ADDENDUM NO: 3

PROJECT: Hamilton Heights High School Phase 2 Projects

PROJECT NO: 2023060

DATE: 03/05/2024

DRAWING TITLE:
PRESS BOX
PLANS -
PLUMBING

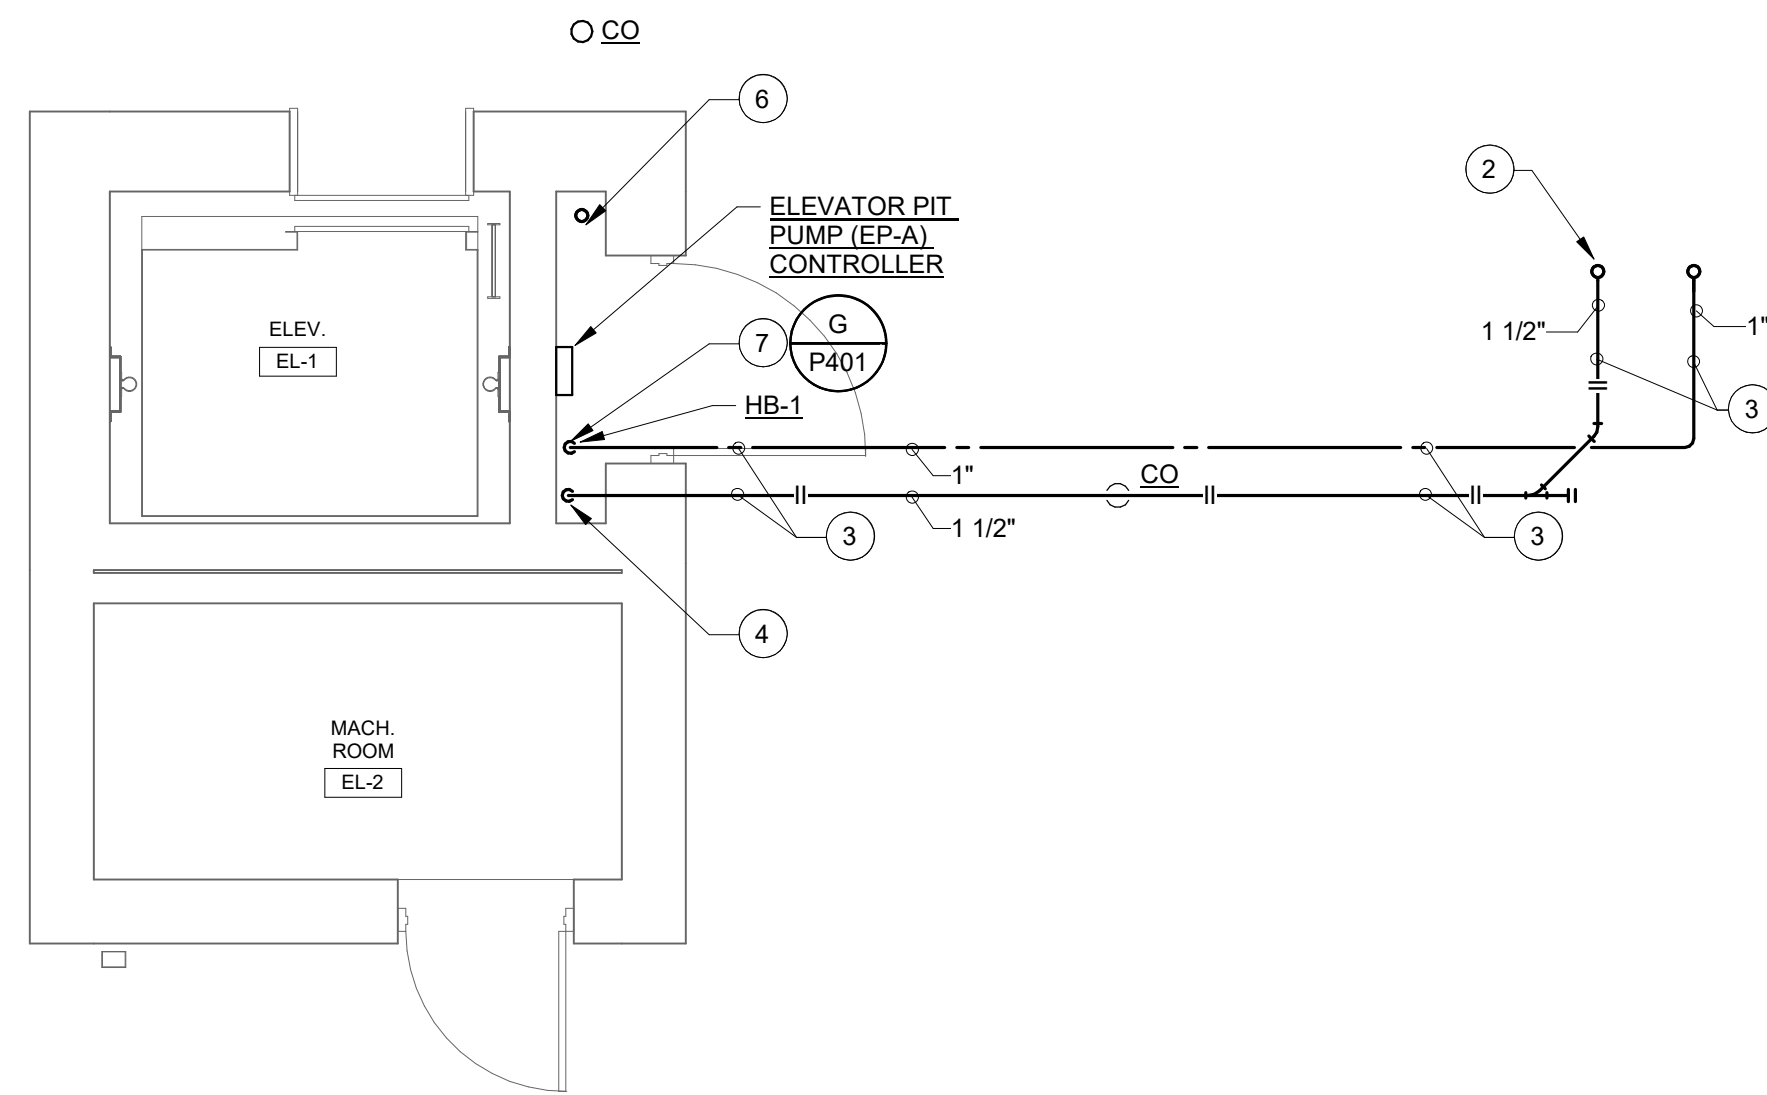
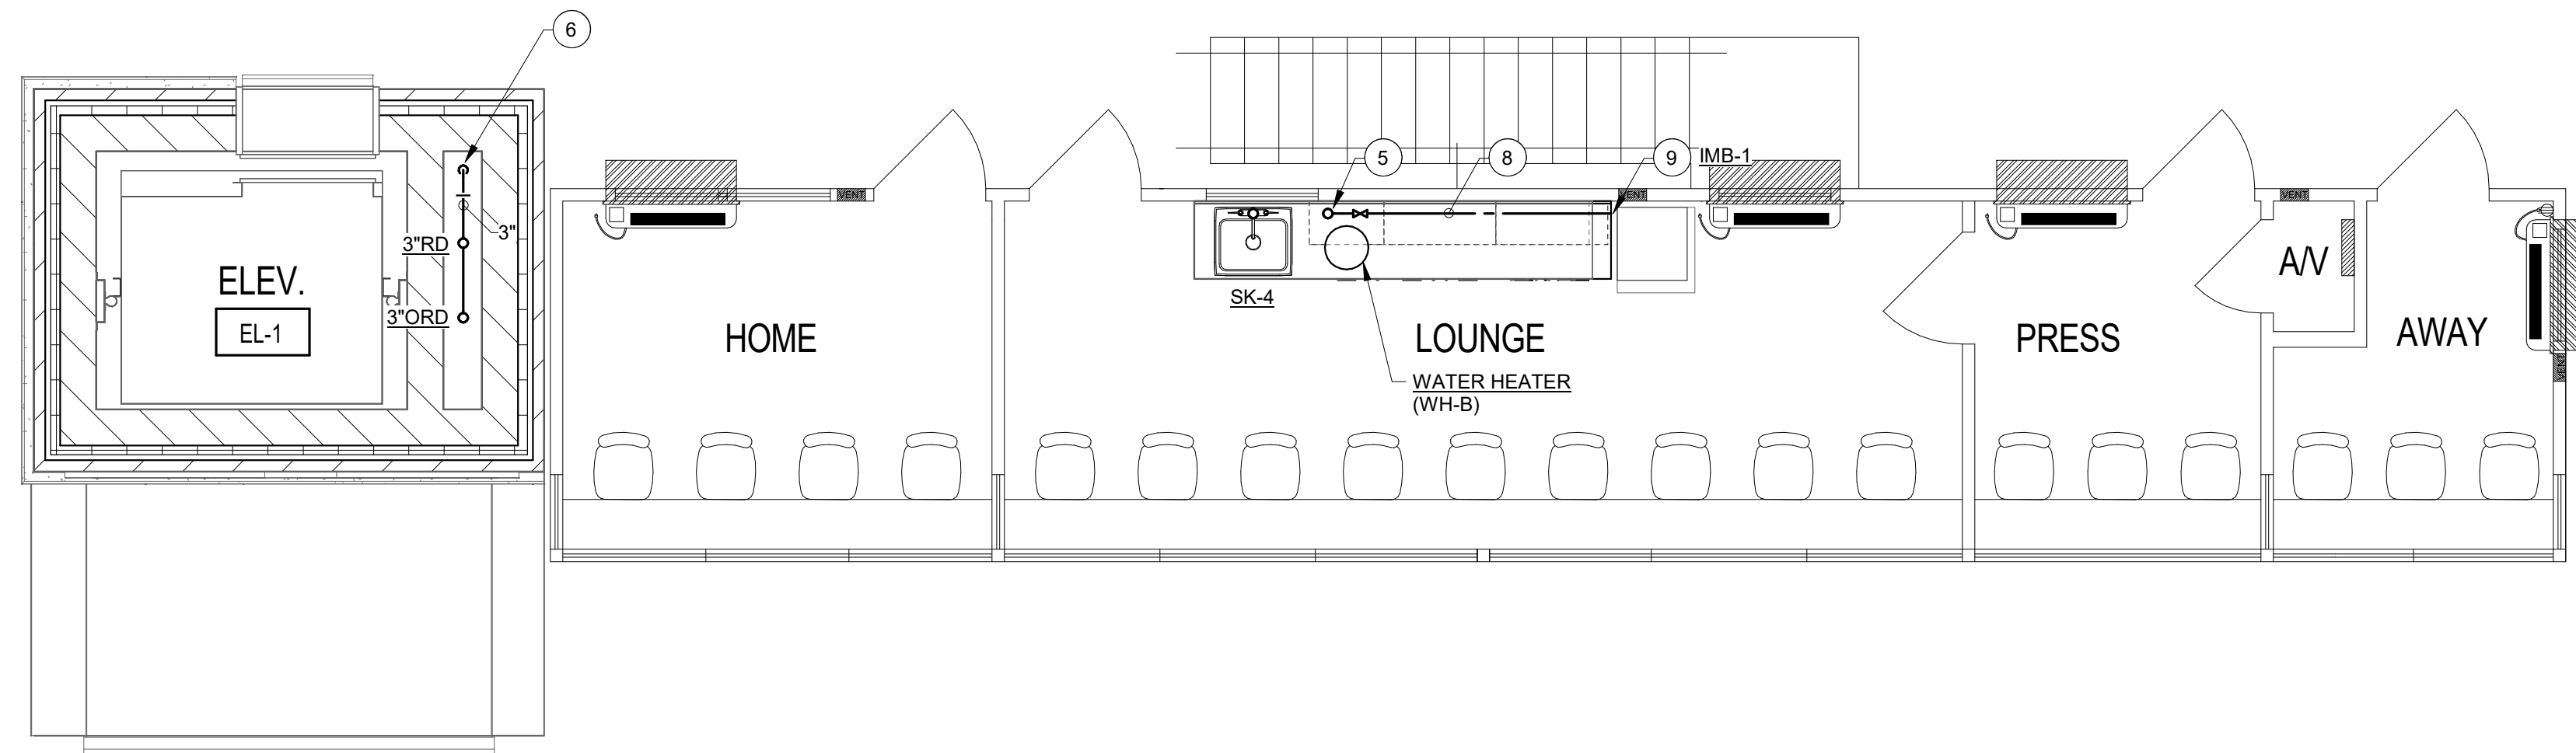
3.10 P204 – PRESS BOX PLANS – PLUMBING

- A. Revise Sanitary and Storm Invert elevations to match Civil

DRAWING TITLE:
**CONTROLS -
CHILLED WATER
SCHEMATIC**

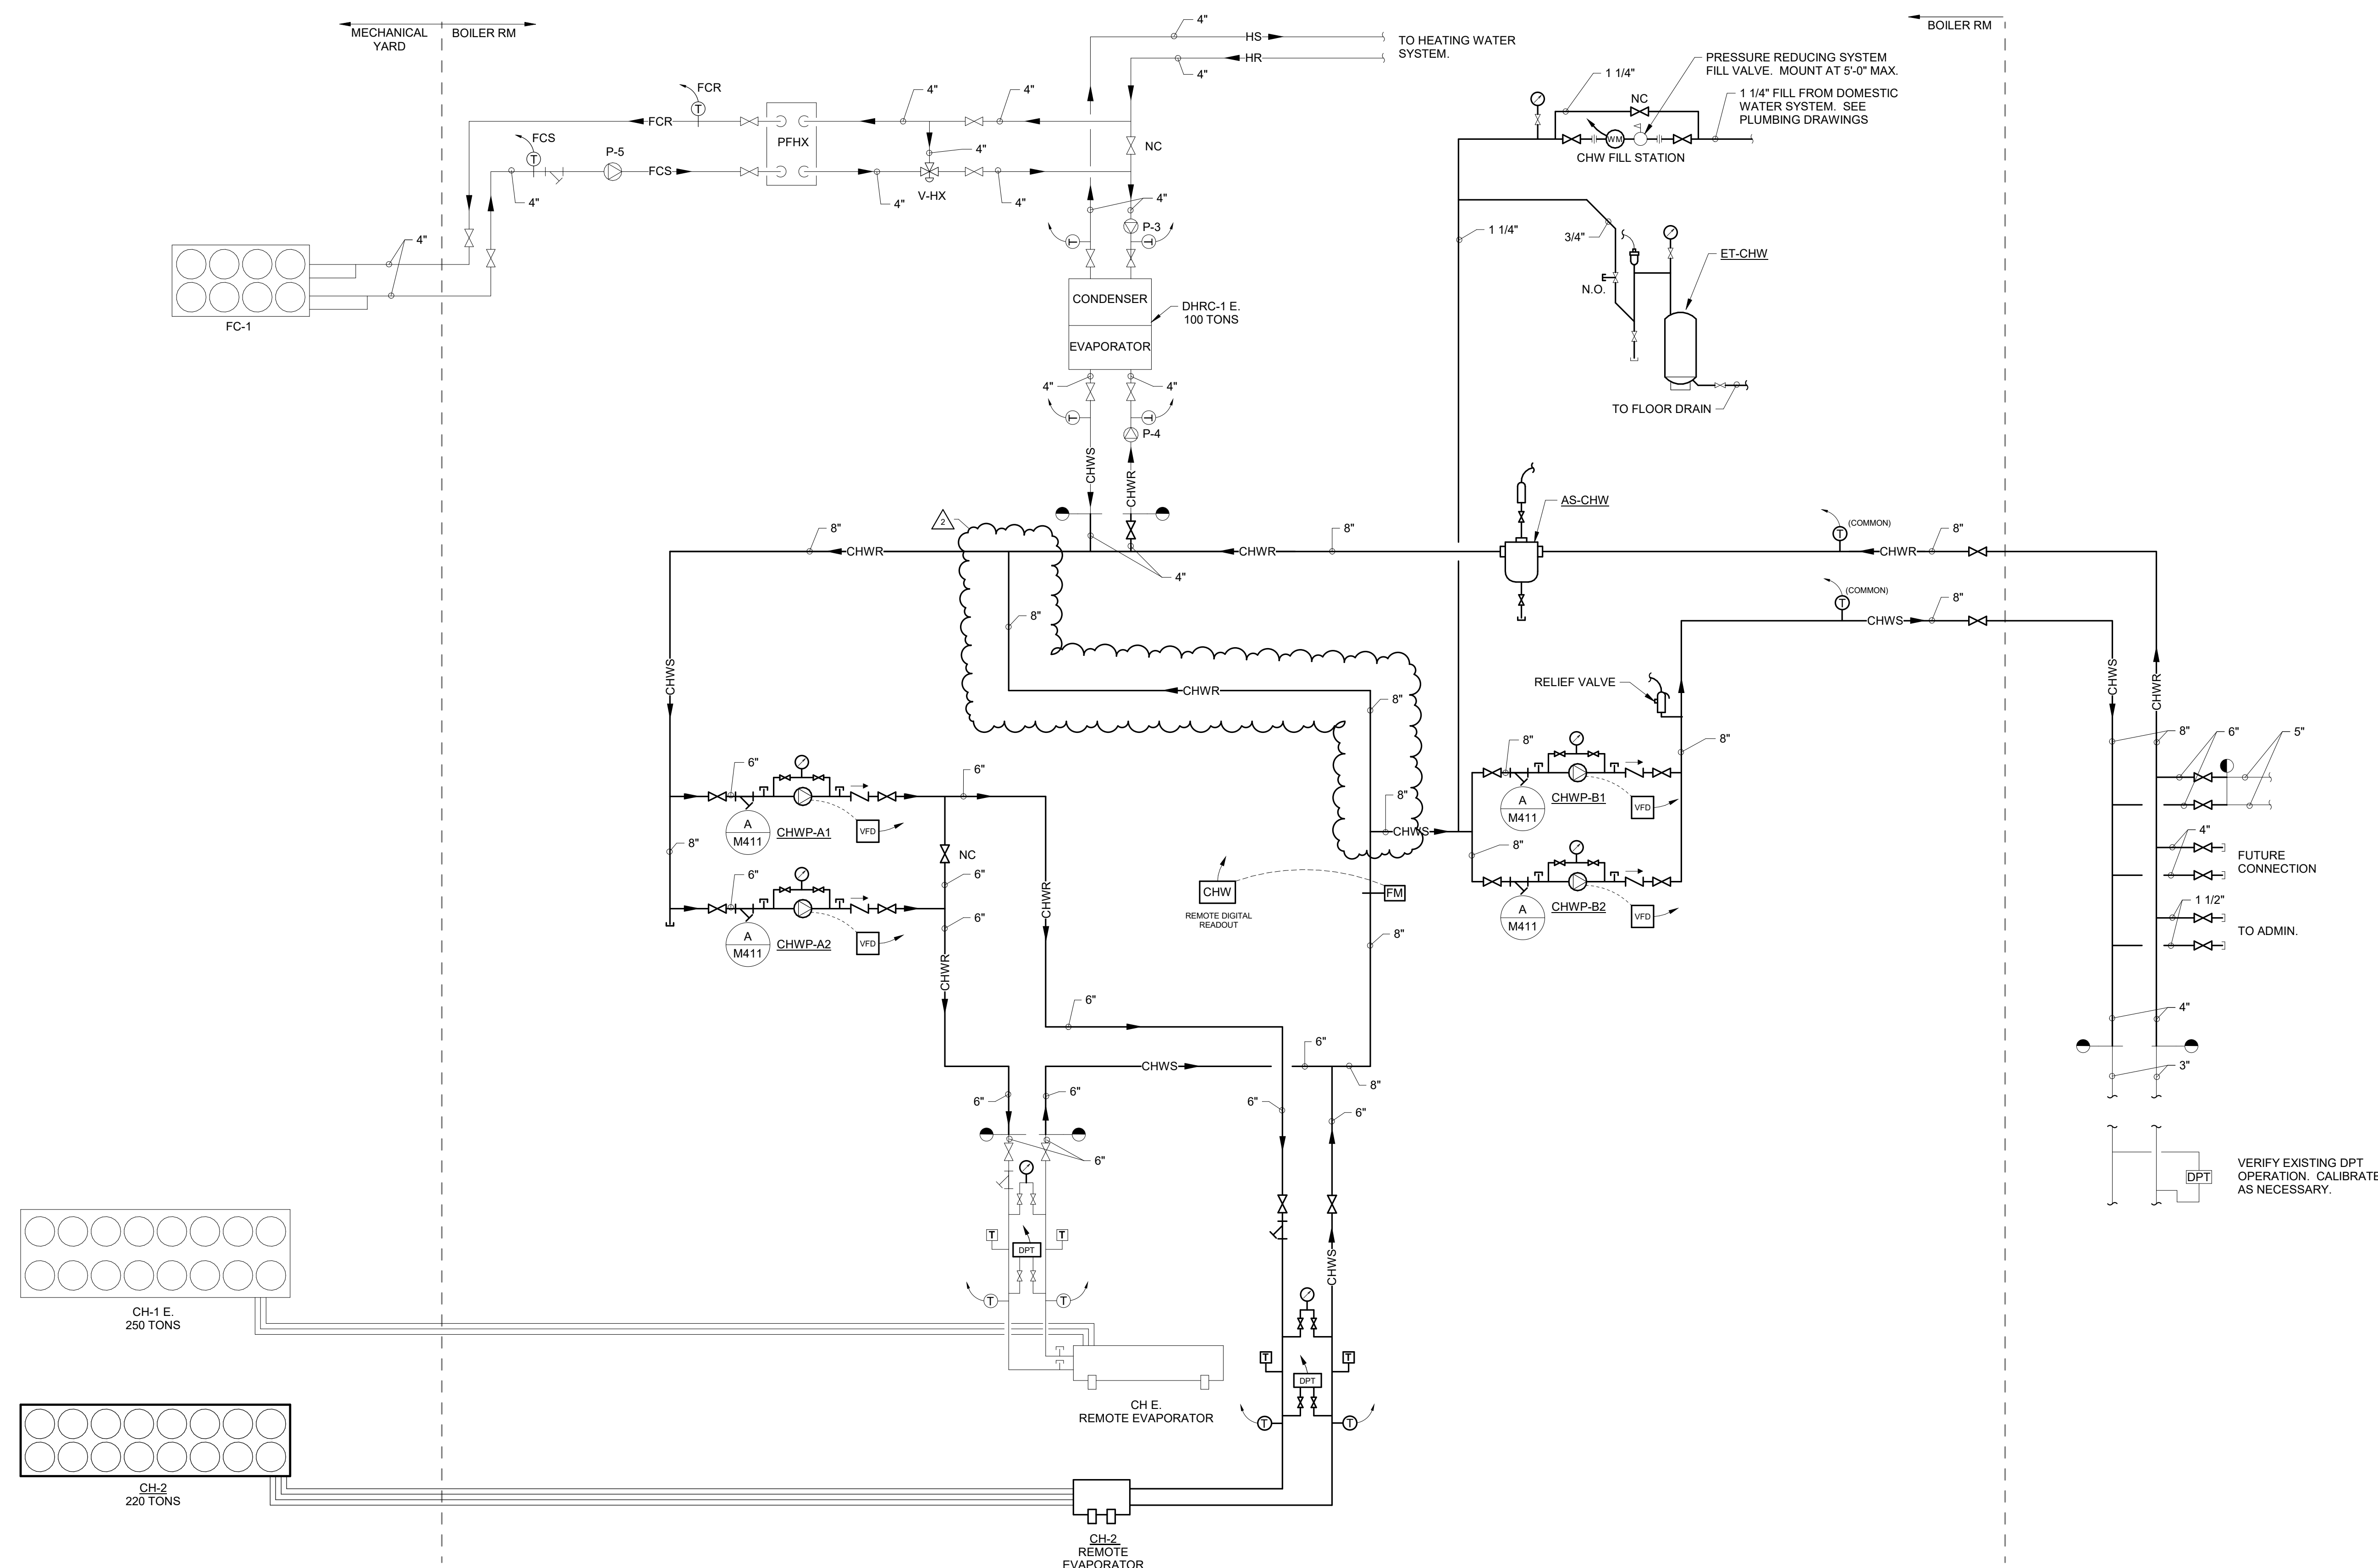
- A. Reissue drawing in its entirety revising chilled water piping schematic

DRAWING TITLE:
SITE PLAN -
ELECTRICAL

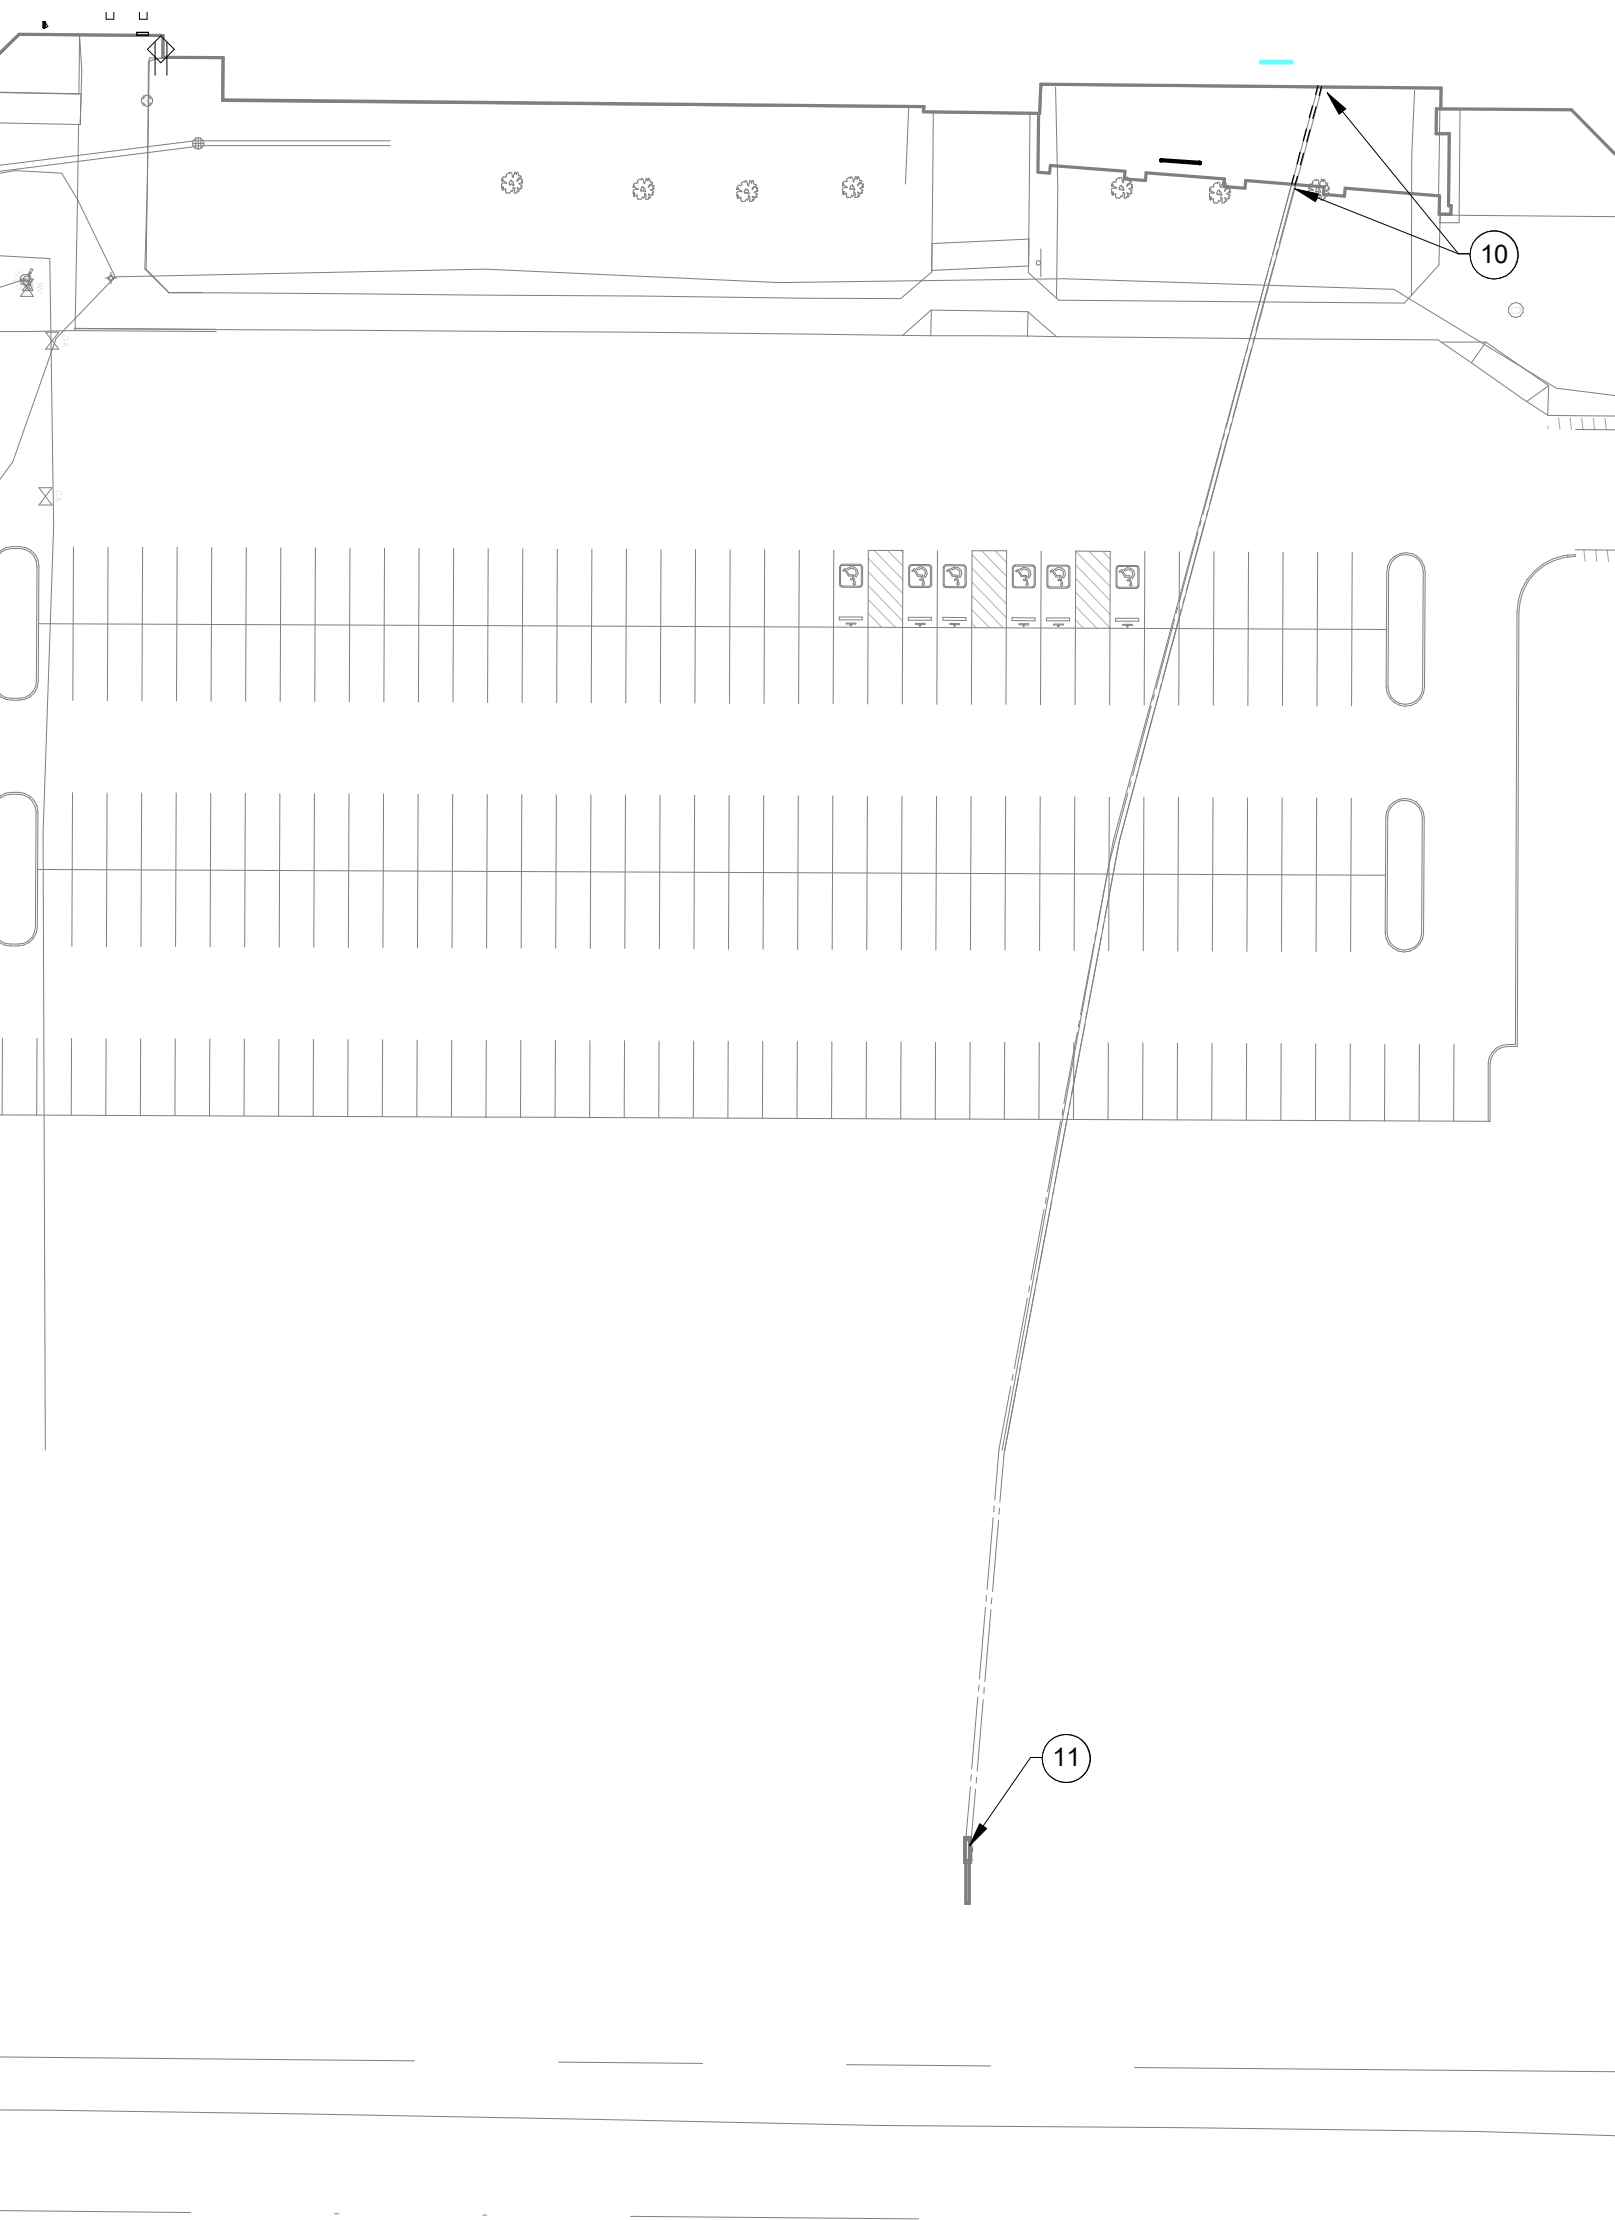
3.14 E100 – SITE PLAN – ELECTRICAL

- A. Reissue drawing in its entirety revising equipment locations behind main football grandstands

Scoreboard is currently a 60A 3PH 3R panel that feeds the play clocks and the sports field boxes. Since the scoreboard is not changing, we suggest changing the feed going to it to a 60A 3PH 4 wire feed that goes back to panel OL1 with a 3P60 breaker added.

This change was made on Addendum #3, Drawing E100.
